[Docket No. FAA-2016-4228; Directorate Identifier 2015-NM-107-AD]

#### Airworthiness Directives; Airbus Airplanes

**ACTION:** Notice of proposed rulemaking (NPRM).

**SUMMARY:** We propose to supersede Airworthiness Directive (AD) 2014-13-12, for all Airbus Model A318, A319, A320, and A321 series airplanes. AD 2014-13-12 currently requires identifying the part number and serial number of each passenger oxygen container, replacing the oxygen generator manifold of any affected oxygen container with a serviceable manifold, and performing an operational check of the manual mask release, and doing corrective actions if necessary. Since we issued AD 2014-13-12, we have determined that affected containers have not only been marked with company name B/E Aerospace, as was specified, but also, for a brief period, with the former company name DAe Systems. This proposed AD would retain the requirements of AD 2014-13-12, and require replacing the oxygen generator manifold of any affected DAe oxygen container with a serviceable manifold. We are proposing this AD to detect and correct non-serviceable oxygen generator manifolds, which could reduce or block the oxygen supply and result in injury

Figure 1 to paragraph (i)(7) of this AD – Design A of the Passenger Oxygen Containers Affected by this AD

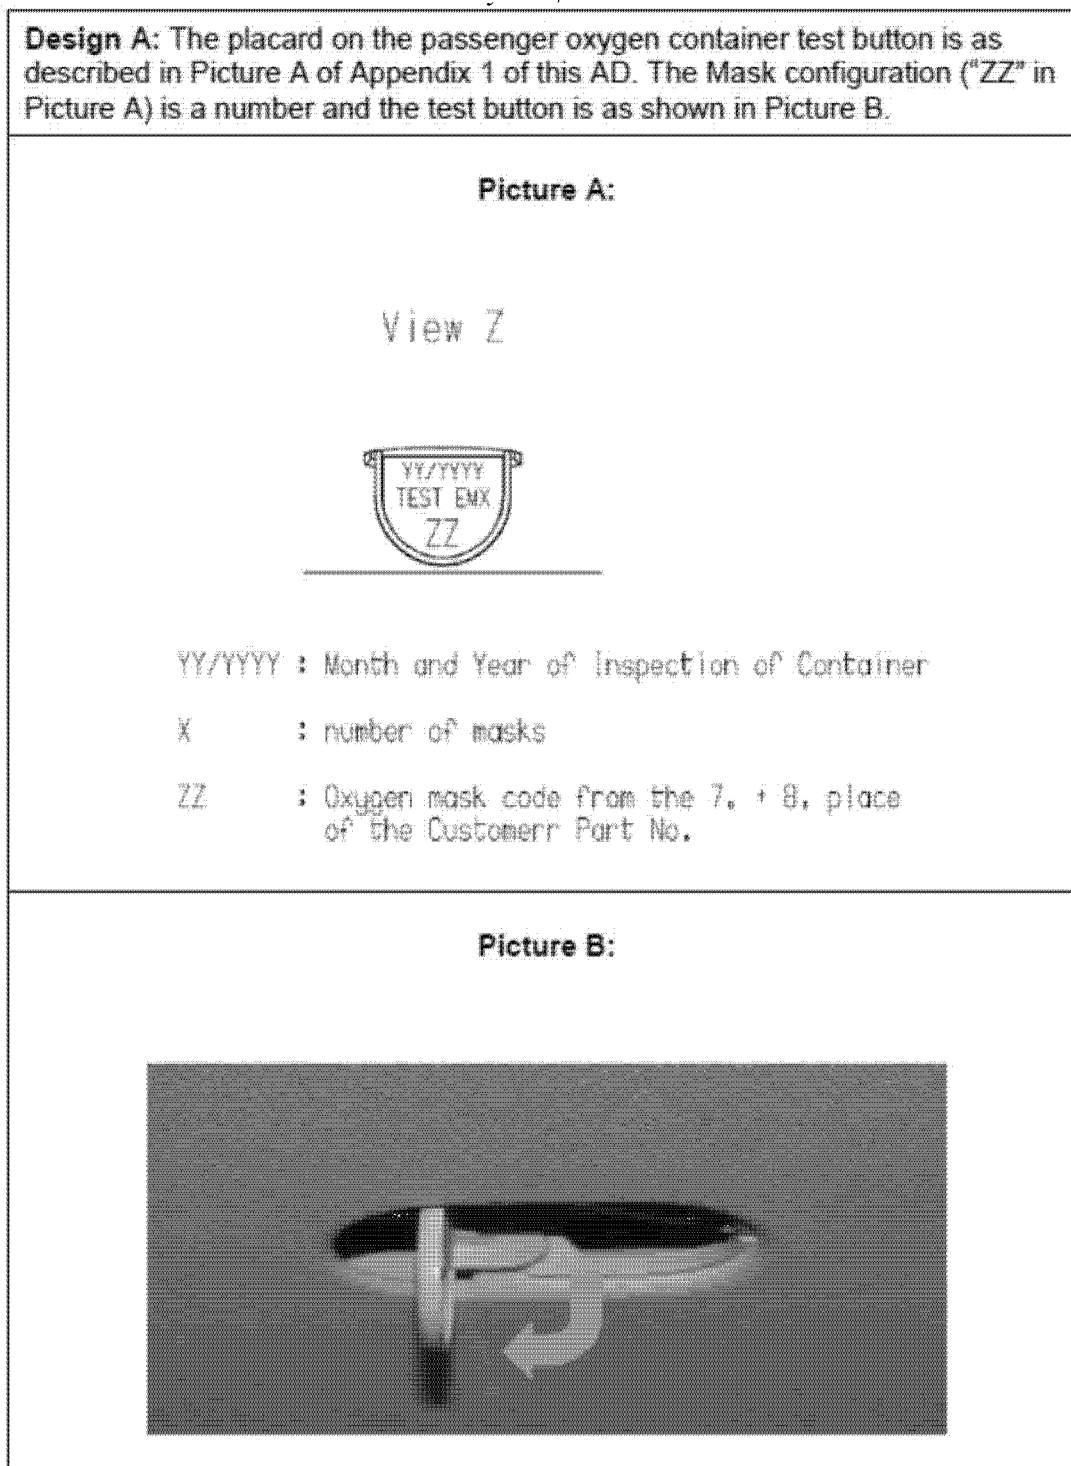
We have added Note 2 to figure 1 to paragraph (i)(7) of this AD, which provides information to clarify information presented in figure 1 to paragraph (i)(7) of this AD.

(7) The requirements of paragraphs (g) and (h) of this AD apply only to passenger oxygen containers that are Design A, as defined in figure 1 to paragraph (i)(7) of this AD.

**Note 2 to figure 1 to paragraph (i)(7) of this AD:** For “Design A,” the placard on the passenger oxygen container test button is as

described in “Picture A” in figure 1 to paragraph (i)(7) of this AD. The mask configuration (“ZZ” in “Picture A”) is a number, and the test button is as shown in “Picture B.”
